# I-94 over Pipestone Road Interchange Feasibility Study Stakeholder Meeting #3

June 5, 2013

# Stakeholder Meeting #3 Agenda

# Draft Alternative 2 (Side Road Ramps)

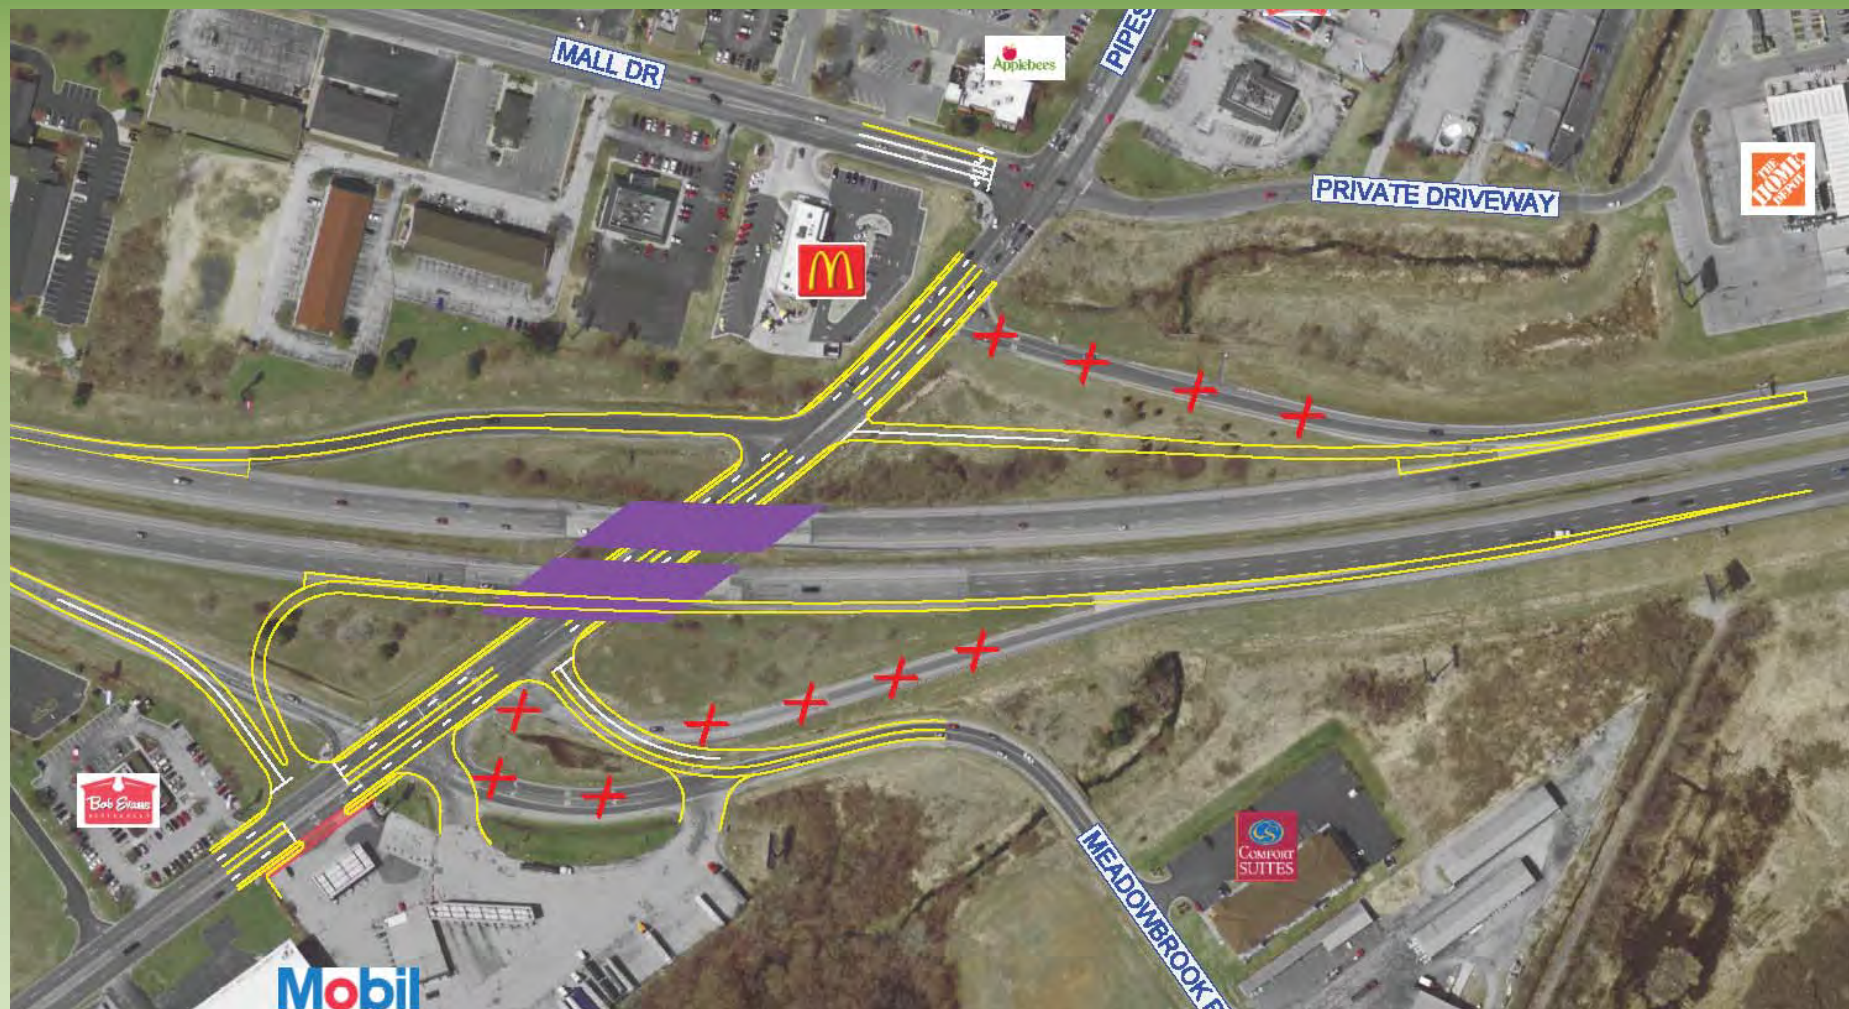
- General Comment
  - Lower I-94 at old railroad crossing.
- Alternative #1 – Diamond Interchange
  - Do not prefer (either side)
  - North side - RT too abrupt, similar difficult RT/LT into Mall Dr
  - South Side – Similar driver confusion (although better than existing).
- Alternative #2 – Side Road Ramps
  - Seems more realistic/helpful to current problems.
- Alternative #3 – Loop Ramp
  - Do not like the loop ramp – geometrics too severe.

# Draft Alternative 4 (One Roundabout)

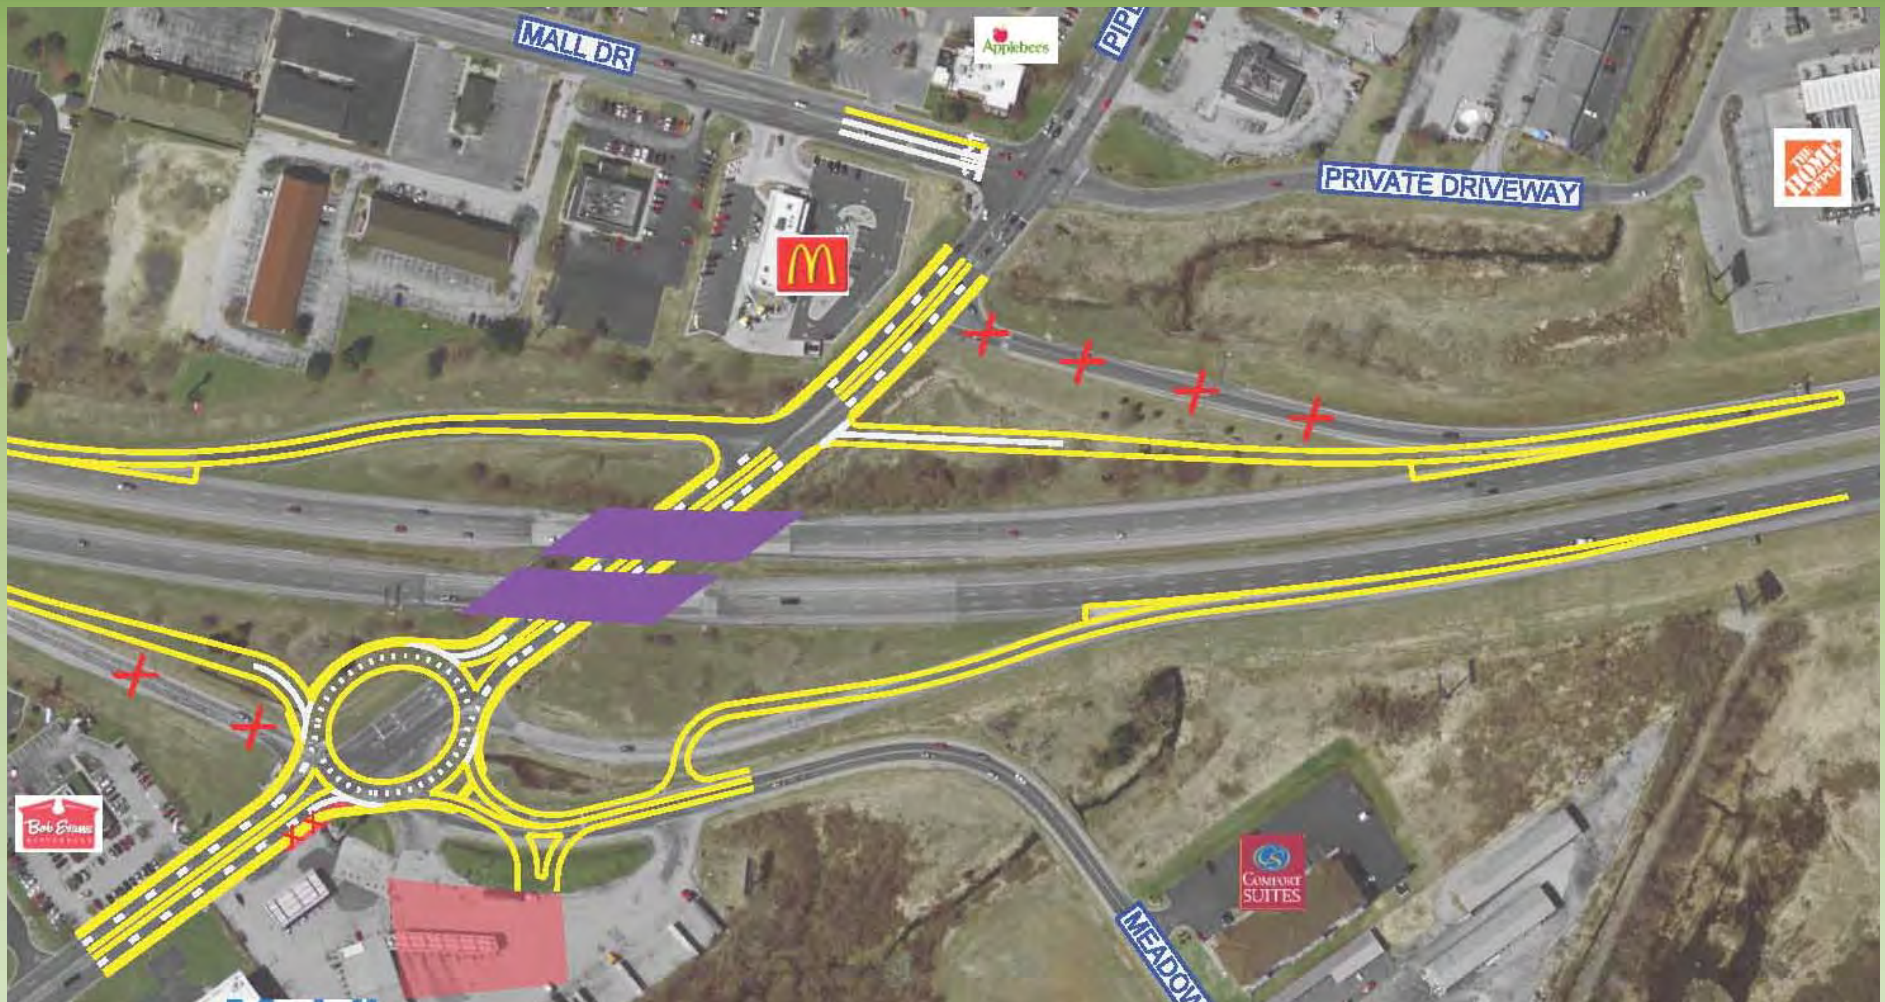
- Alternative #4 – One Roundabout
  - North Side – RT too abrupt, similar difficult RT/LT into Mall Dr
  - South Roundabout – Don't care for severity of curves and Mobil access. Could combination of entry ramp and Meadowbrook help solve that?
- Alternative #5 – Two Roundabouts
  - Do not prefer (either side)
  - North Roundabout – I like it, must consider truck movements.
- Alternative #6 – Relocate Private Drive
  - North side – I like this as well.
  - Do we need private driveway or could it be made right-in/right-out access? Could MDOT provide/enhance other access points.

- Alternative #1 – Diamond Interchange
  - Least favorite.
- Alternative #2 – Side Road Ramps
  - Not an option – congestion on side roads.
- Alternative #3 – Loop Ramp
  - South ramp (EB Entrance) not an option (too steep)
  - North ramp (WB Exit) as best option.
- Alternative #4 – One Roundabout
  - Best option.
  - North Ramp (yes) – South Ramp (yes)
